December 20, 2021

Consideration of a Site Plan and Architectural Review application for the development of a twenty one (21) space parking lot expansion, including paved circulation areas, curbs, and landscape areas. The approximately 0.25 acre project site is located at 1710 East Pine Street within the Tourist and Office Professional (C-4) commercial zoning district and is identified on the Jackson County Assessor's map as 37S 2W 02D Tax Lot 2200. **Applicant:** Hunter Seven, LLC; **Agent:** Gary Caperna.

Staff Source

Justin Gindlesperger, Community Planner II

PLAN VIEW - OVERALL SITE PLAN
SCALE: 1" = 30'-0" (GRAPHIC)

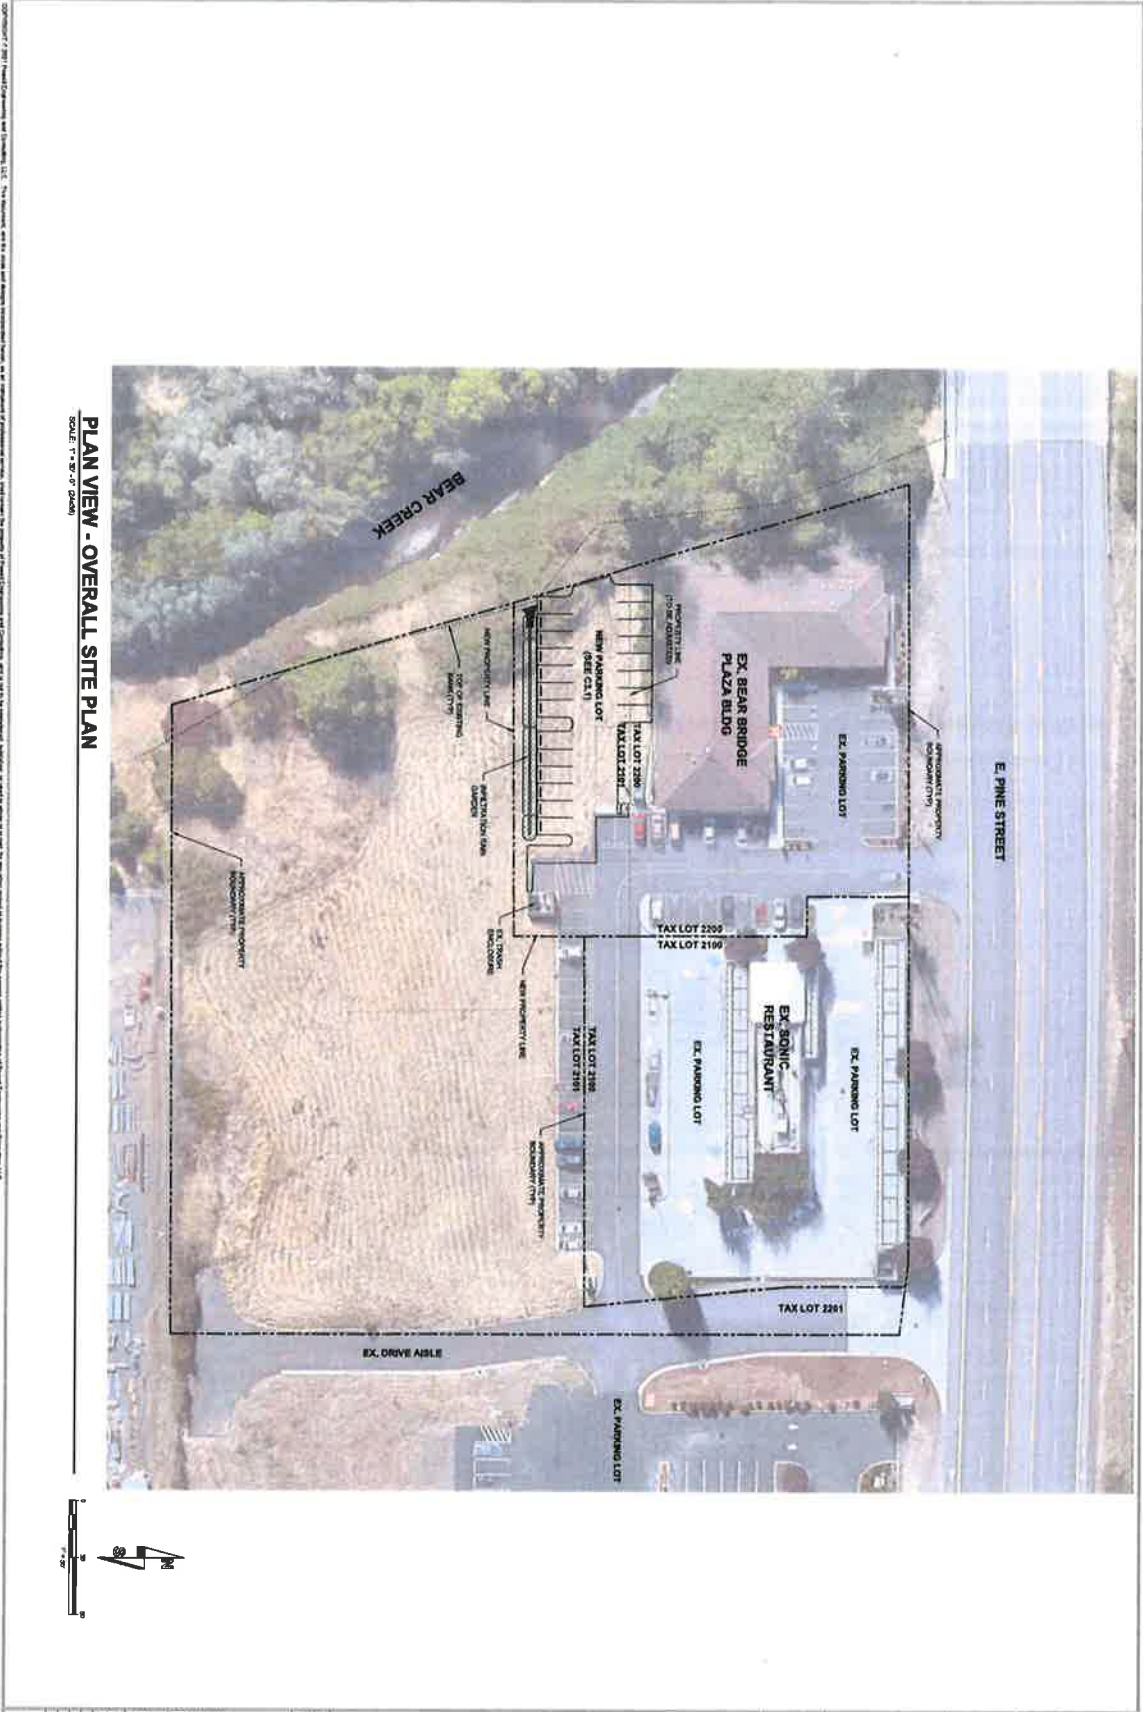
1. **Property Lines.** The south portion of the proposed improvements extend onto the adjacent property, which is not part of the proposed development. A Lot Line Adjustment is needed so the improvements are located entirely on the subject property.

2. **Landscape Plan.** The landscape plan depicts interior and perimeter landscape areas (Attachment "A-2"). The proposed terminal islands along the west side of the proposed parking area are not wide enough. Terminal islands must be a minimum of six (6) feet in width, per CPMC 17.75.039(G)(2). The landscape plan shows the northwest terminal is 5-ft in width at the narrowest point. The south terminal doesn't meet the minimum 6-ft standard at any point.

Comment: The site and landscape plan need to be revised to comply with the parking lot landscape standard for terminals. Based on staff's review it appears that this will result in the loss of one parking space leaving a total of 45 spaces to serve the Bear Bridge Plaza. As noted above, the minimum parking spaces required is 48. In accordance with CPMC 17.64.040(B)(1), off-street parking can be reduced by a maximum of twenty (20) percent. The loss of one parking space would result in a 6.25% reduction consistent with allowable adjustment and bring the Bear Bridge Plaza into compliance with the off-street parking standards for the mix of commercial uses occupying the site. Staff recommends Condition of Approval No. 1(b) requiring a revised landscape plan that depicts terminal islands of a minimum of six (6) feet in width as required per CPMC 17.75.039(G)(2).

Comment: Staff recommends Condition of Approval No. 1(a) requiring the applicant to provide complete a Lot Line Adjustment in order to eliminate the encroachment onto the adjacent property.

1. Prior to building permit issuance, the applicant shall:
 - a. Submit a recorded Final Map of Survey for a Lot Line Adjustment for the area of encroachment. An application and approval of tentative plan for Lot Line Adjustment must precede the Final Map of Survey.
 - b. Submit a revised landscape plan that depicts terminal landscape areas of a minimum of six (6) feet in width.
